**Economic and Social Council**Distr.: General
20 July 2018English
Original: English and French

Economic Commission for Europe**Inland Transport Committee****World Forum for Harmonization of Vehicle Regulations****Working Party on General Safety Provisions****115th session**

UN Regulation No. 73 (Lateral protection devices)**Proposal for the 02 series of amendments to UN Regulation No. 73
(Lateral protection devices)****Submitted by the expert from France***

Figure 1

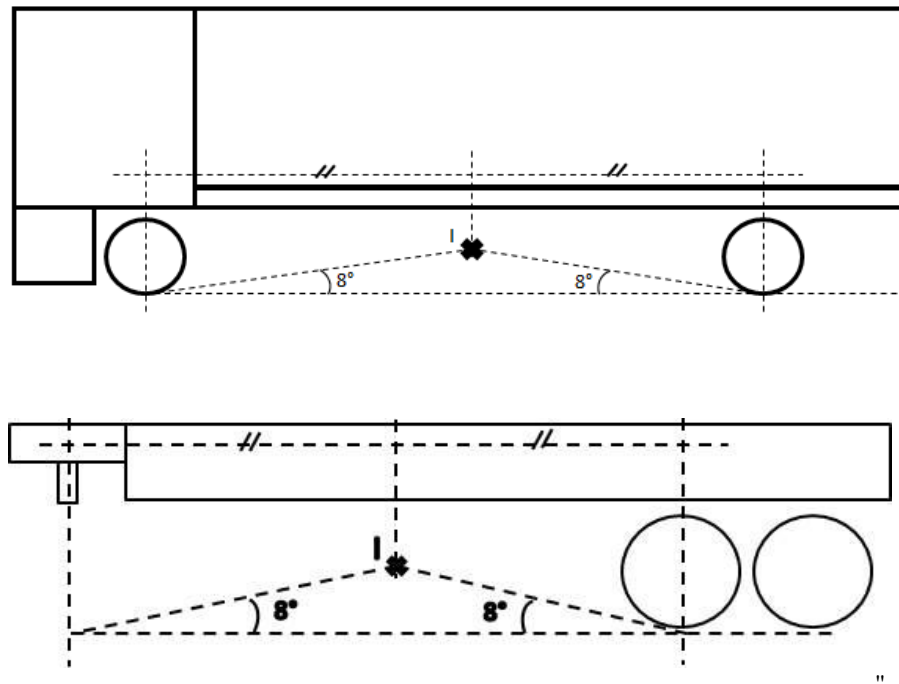
- "12.8. The lower edge of LPD shall **be defined as follows:**
- (a) **If $I \leq 350$ mm then the ground clearance can be 350 mm maximum;**
 - (b) **If $350 \text{ mm} < I \leq 450$ mm then the ground clearance is I;**
 - (c) **If $450 \text{ mm} < I$ then the ground clearance is 450 mm maximum;**
- with intersection point I defined as mentioned in Figure 1.**

Figure 2

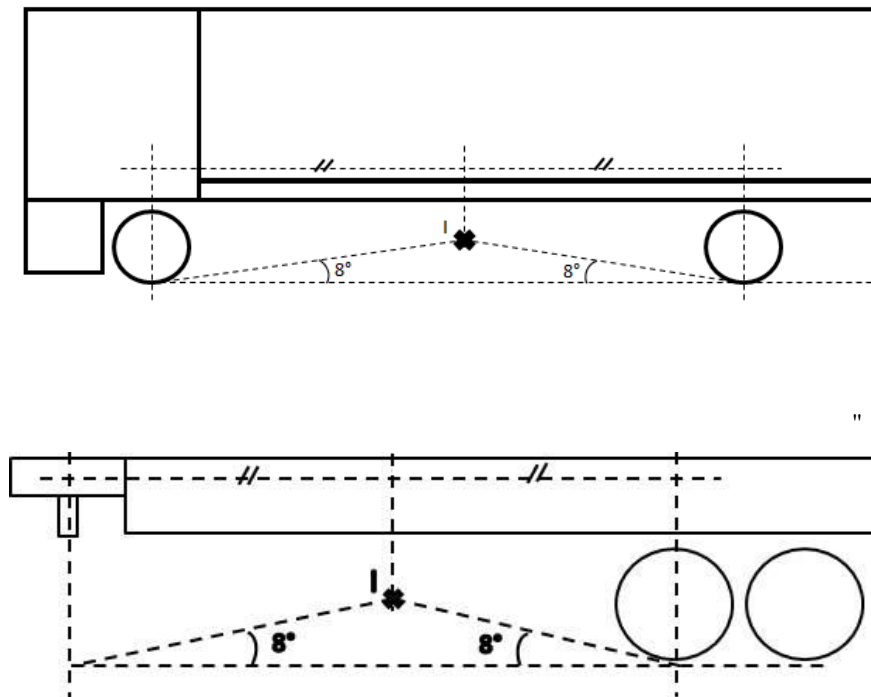
"15.6. The lower edge of LPD shall **be defined as follows:**

- (a) **If $I \leq 350$ mm then the ground clearance can be 350 mm maximum;**
- (b) **If $350 \text{ mm} < I \leq 450$ mm then the ground clearance is I;**
- (c) **If $450 \text{ mm} < I$ then the ground clearance is 450 mm maximum;**

with intersection point I defined as mentioned in Figure 2.
